Application No.: 10/518,185
Amendment Dated: January 31, 2007
Reply to Office Action of: October 31, 2006

MAT-8579US

Amendments to the Drawings:

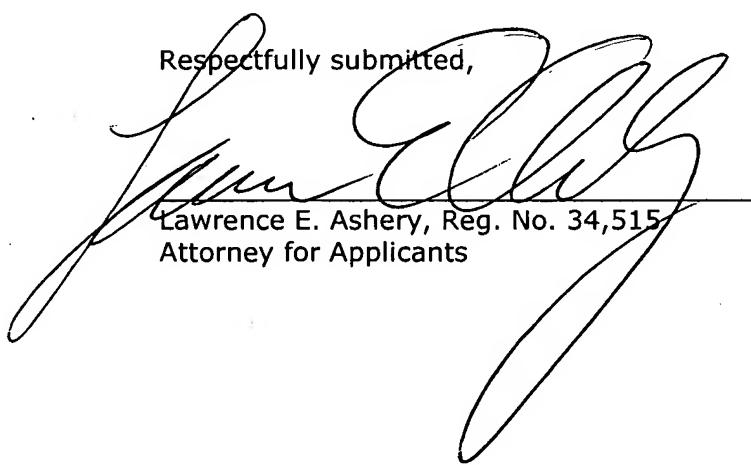
Fig. 1 has been objected to. In particular, blocks 102 and 109 are mislabeled as a "non-linear distortion compensating section" and "instantaneous power calculator," respectively. Blocks 102 and 109 have been amended accordingly. Applicants respectfully request that the objection to Fig. 1 be withdrawn.

The attached sheet of drawing includes changes to Figure 1. This sheet replaces the original sheet.
